ADDENDUM NUMBER THREE

10 November 2025

NC Department of Natural and Cultural Resources
Fort Fisher Aquarium – Renovation & Expansion
Phase 1
SCO ID #17-18042-02A

LS3.49

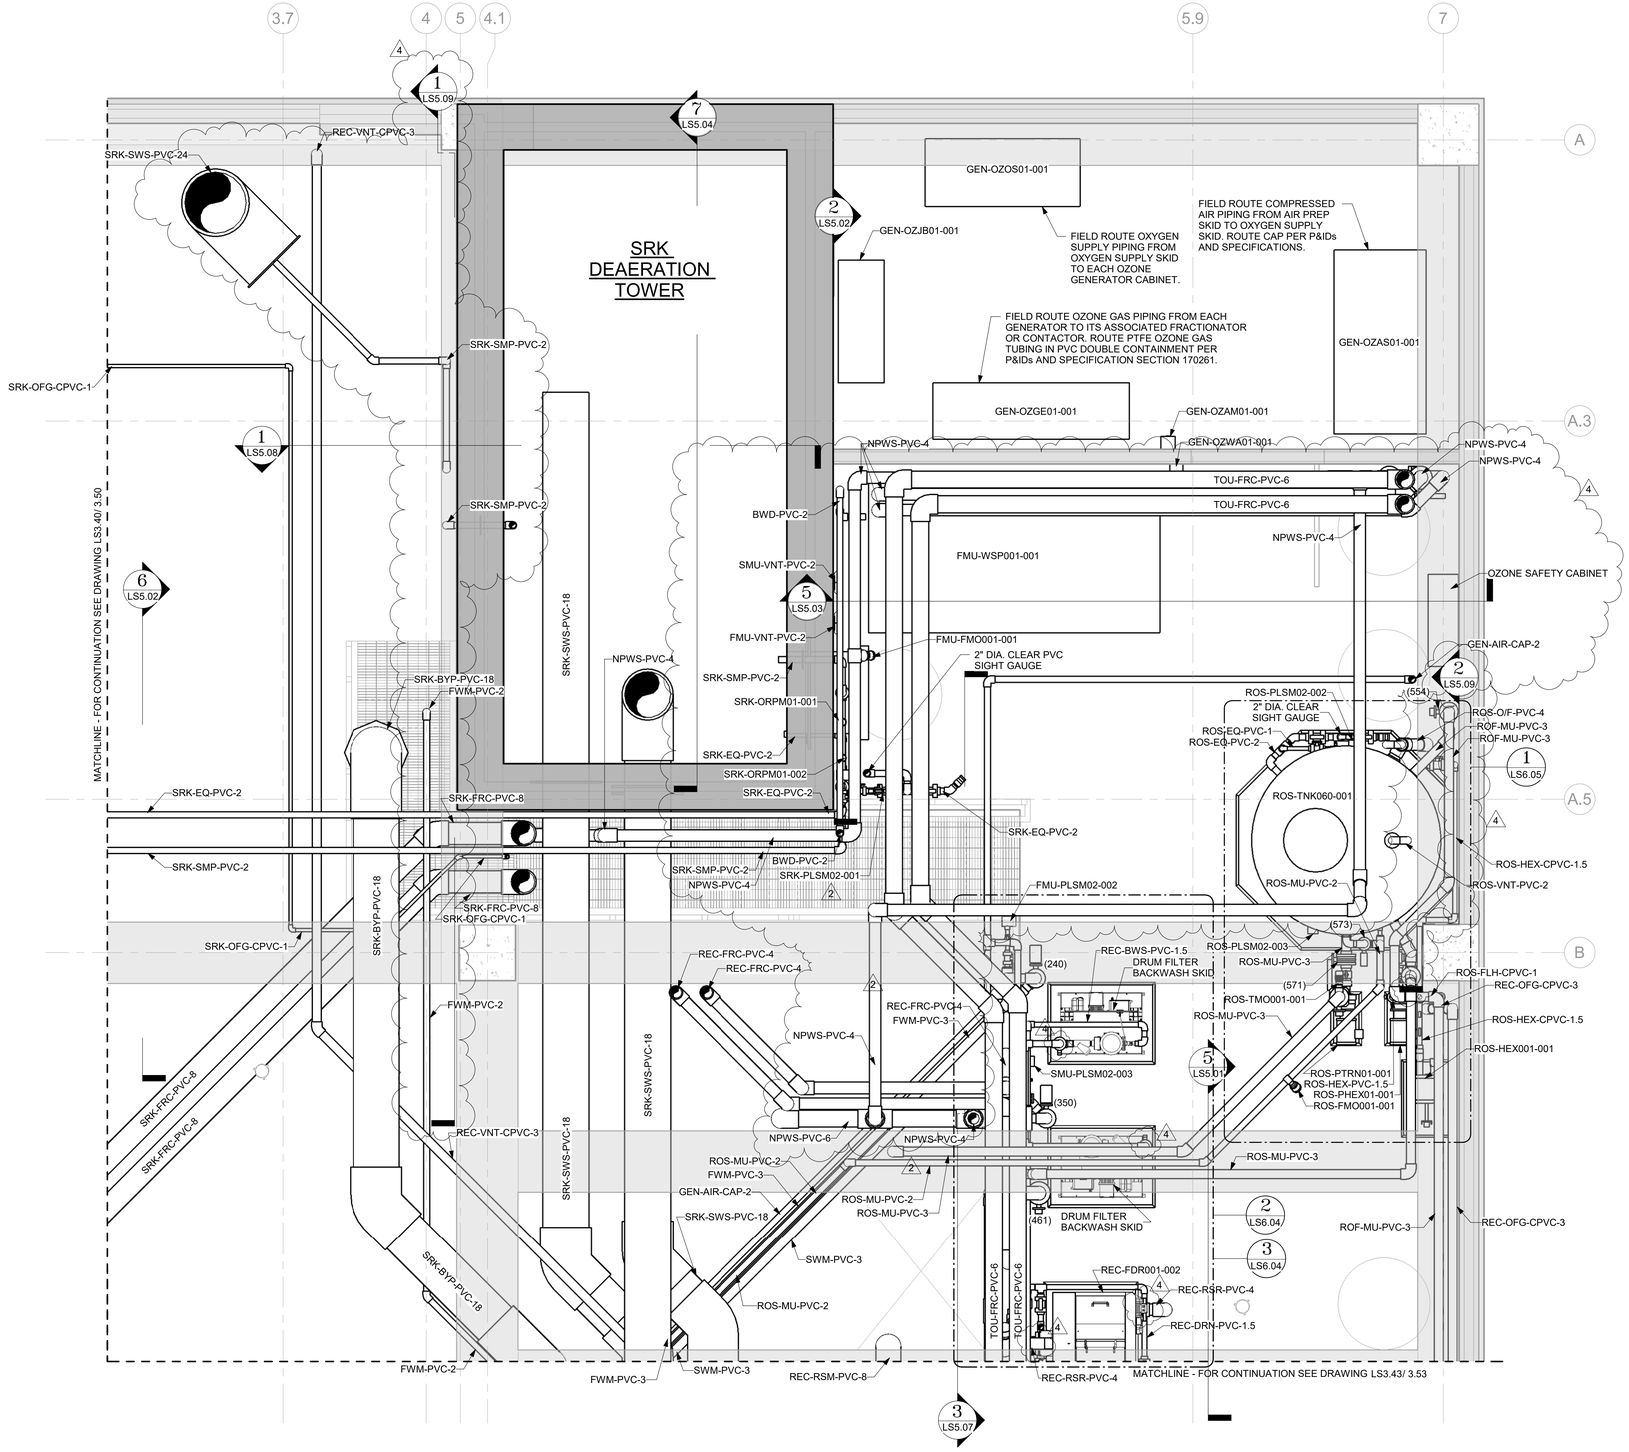
133. LS3.49: ENLARGED LSS CEILING PLAN - EXOTICS - EL. 16.67' TO 19.25'
   a. Added notes clarifying exotics aquatics add alt 3 scope

LS3.51

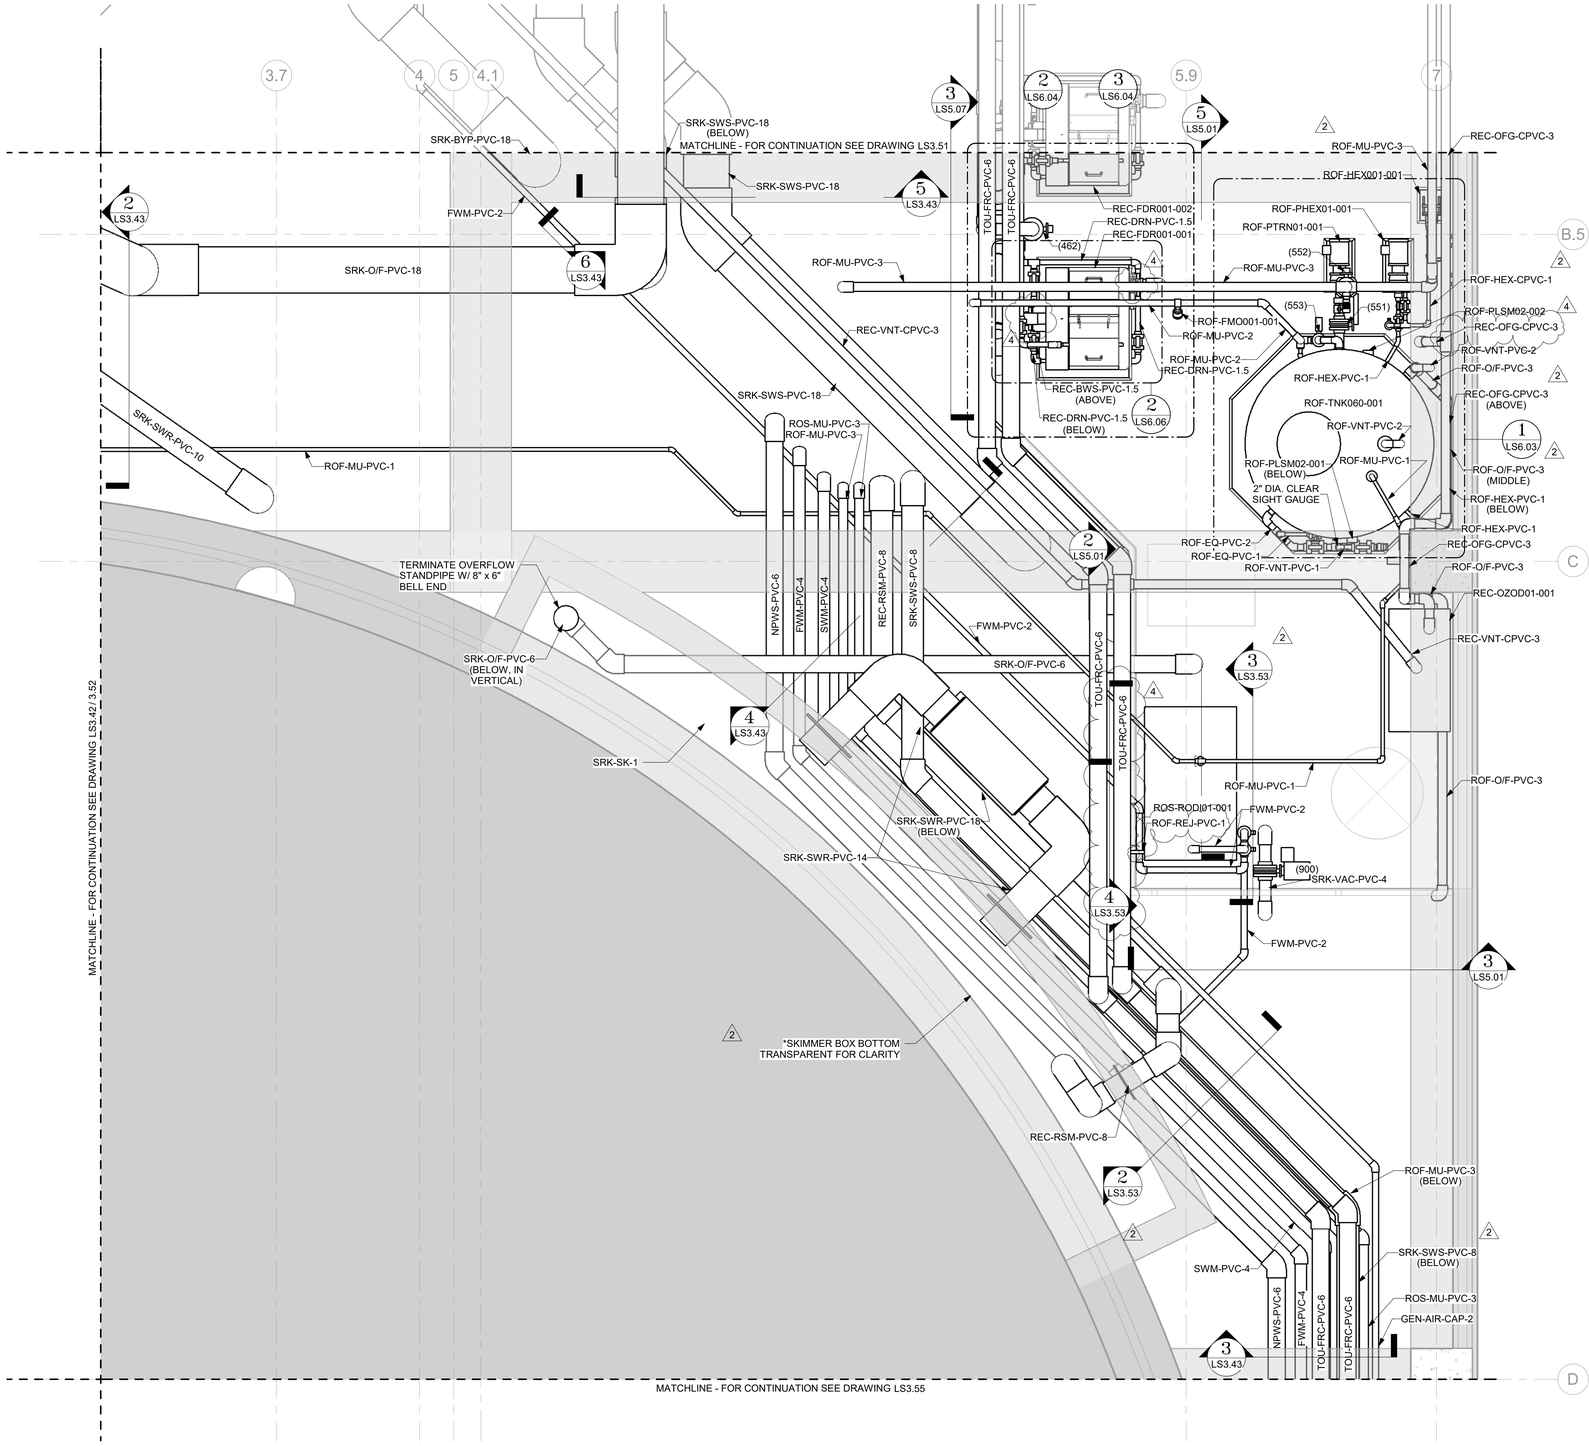
134. LS3.51: ENLARGED LSS PLAN - 2ND FLOOR ADMIN CEILING PLAN - EL. 23.94' TO 34.78'
   a. Added 2" BLV on drum filter NPWS to match P&ID.
   b. Add section 1/5.09 to clarify piping.
   c. Revise SRK tower ORP smp piping.
   d. Revised piping to and from water softener skid, added water softener bwd piping, and rearranged SRK tower pressure transducer and sight gauge
   e. Relocated section 5/5.03 to behind ROS tank for clarification.
   f. Added section 2/5.09.

LS3.54

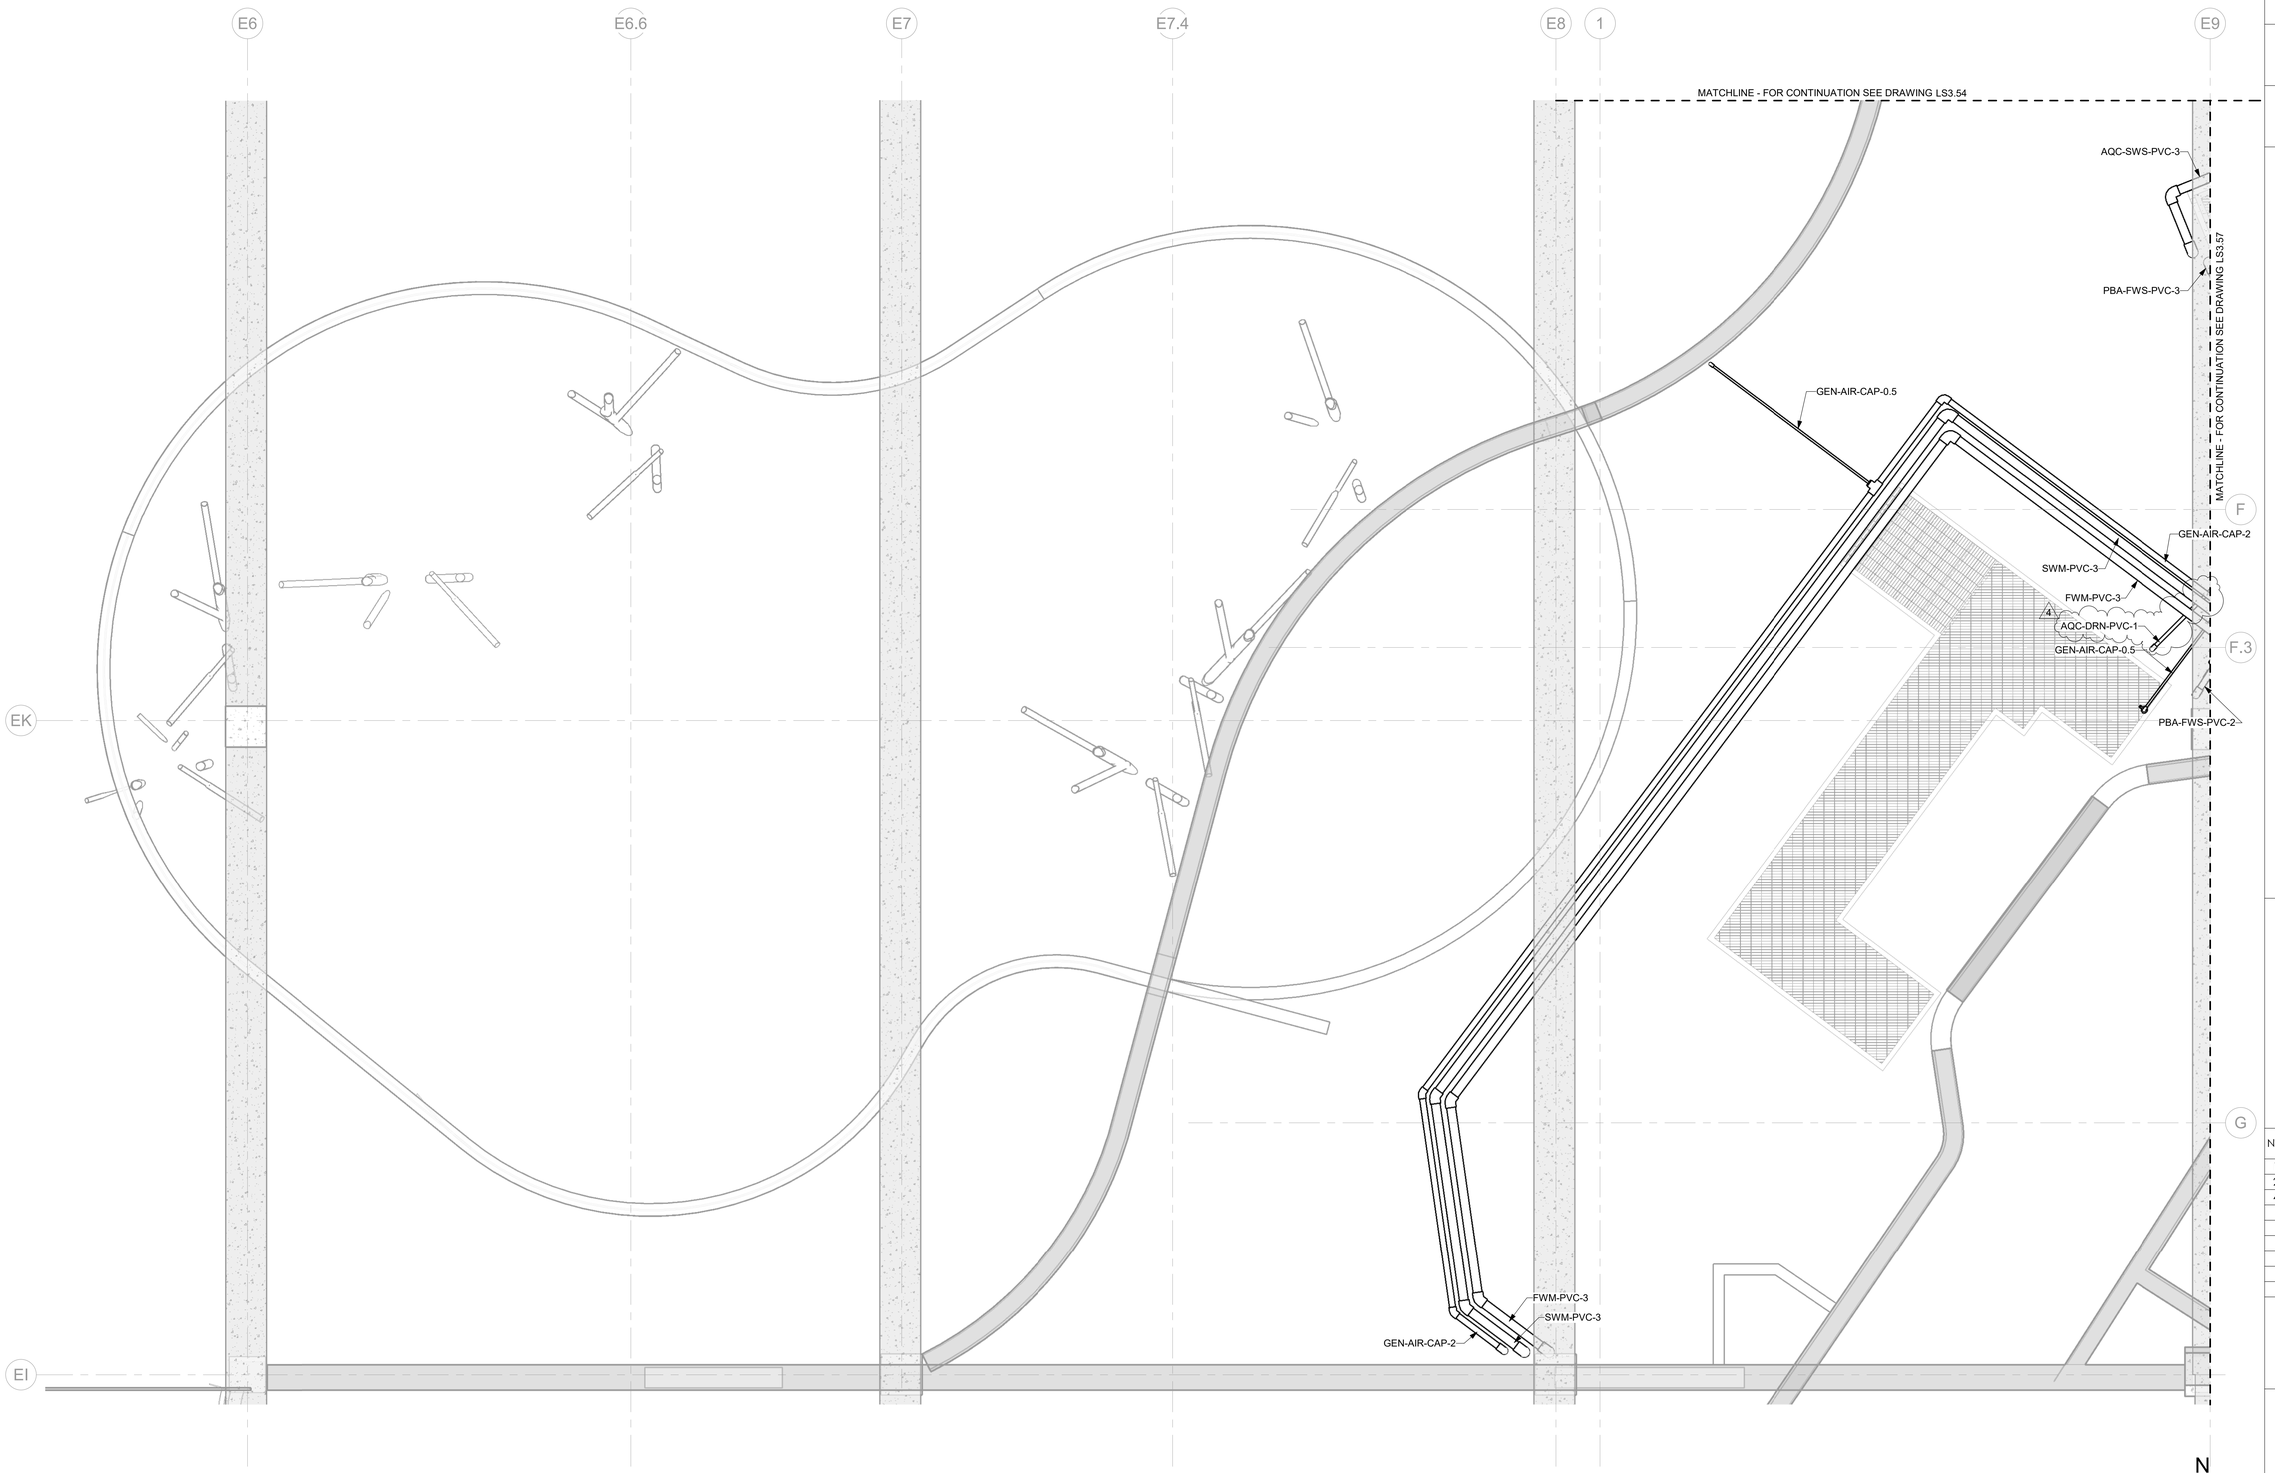
137. LS3.56: ENLARGED LSS PLAN - 2ND FLOOR ADMIN CEILING PLAN - EL. 26.69' TO 34.36'
   a. Routed AQC frac drain to floor drain near PBA reservoir

LS3.59

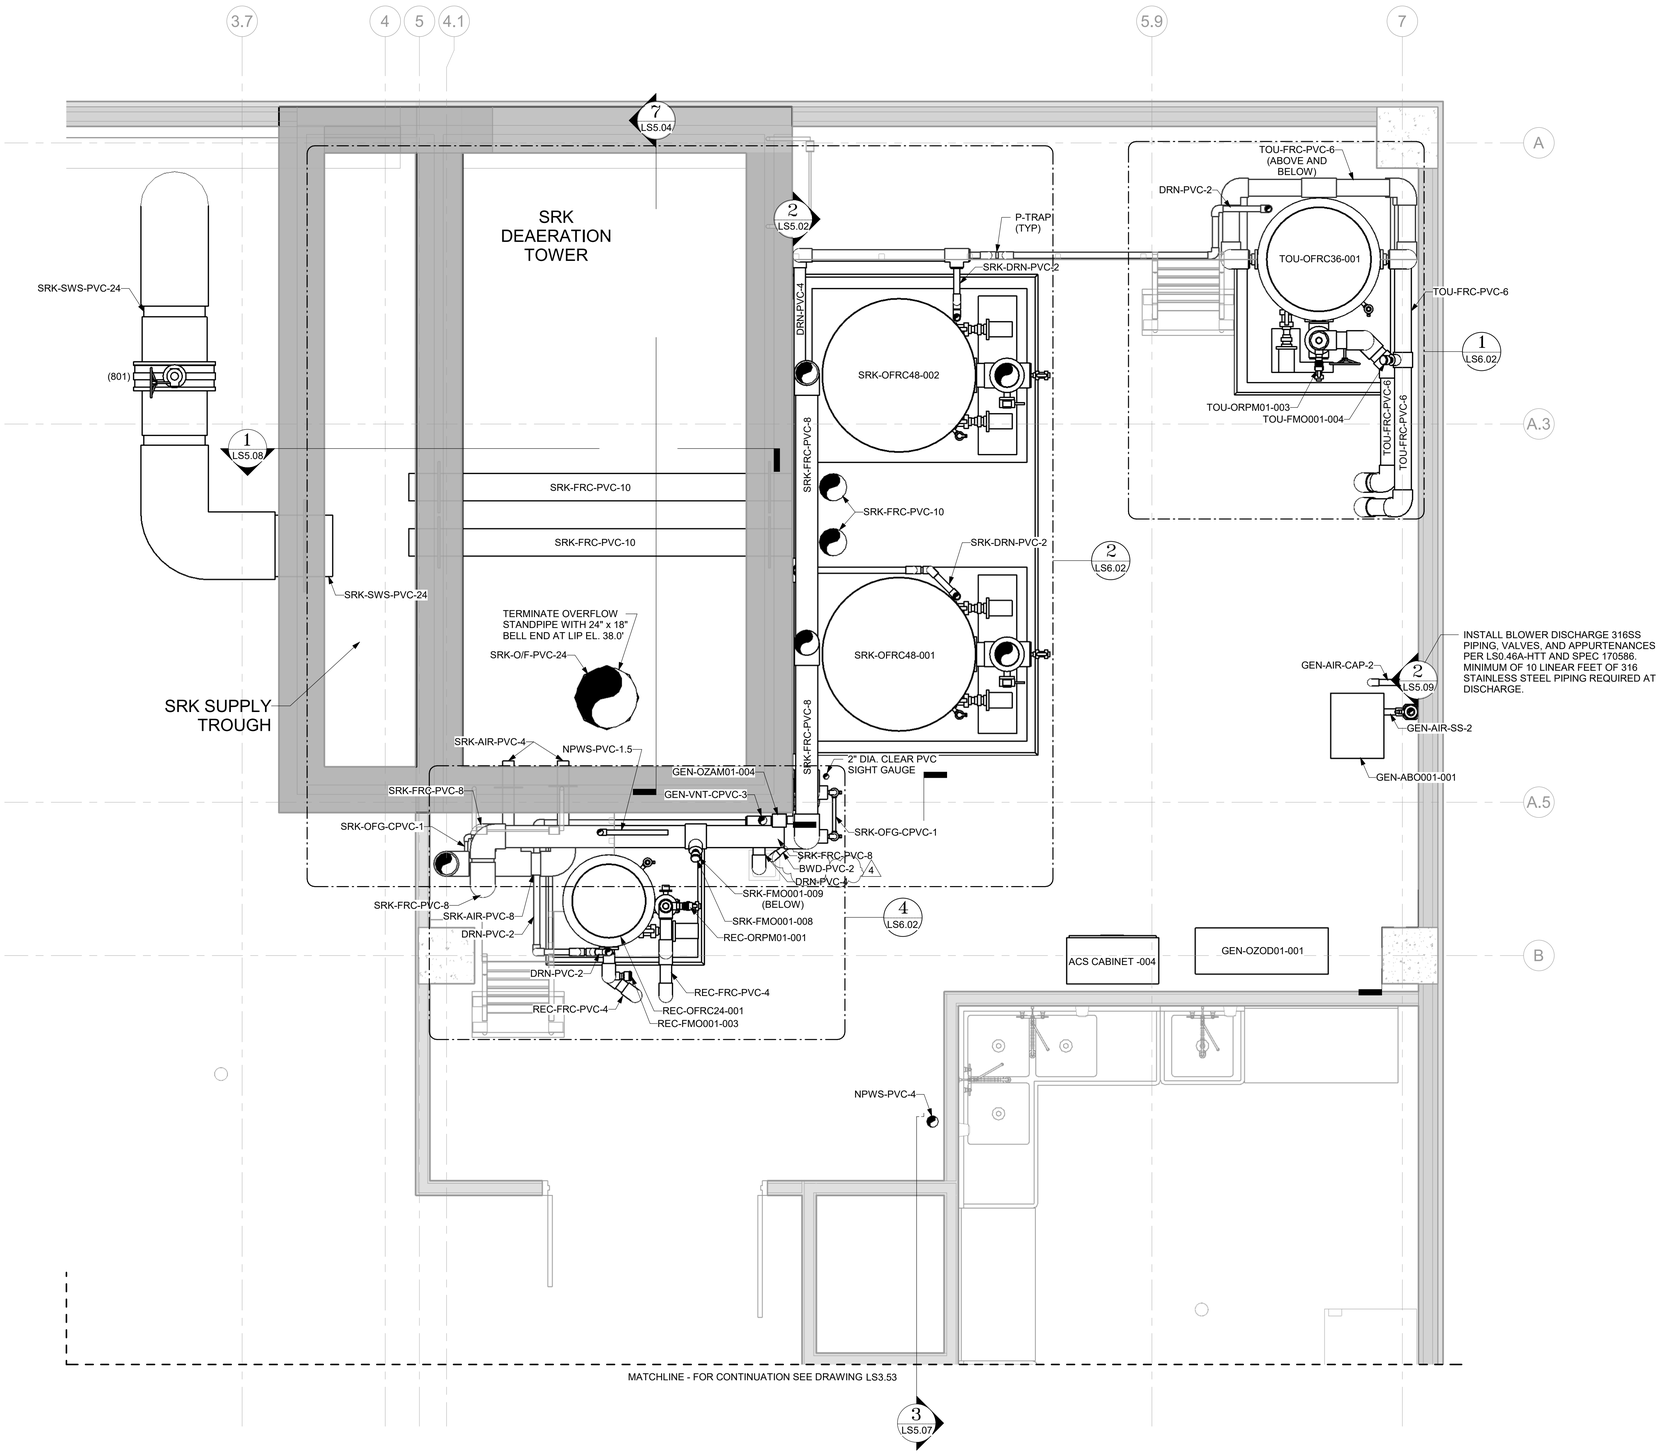
140. LS3.59: ENLARGED LSS CEILING PLAN - CYLINDERS - EL. 10.83' TO 19.36'
   a. Added notes to clarify exotics aquatics Add-Alt #3 scope.
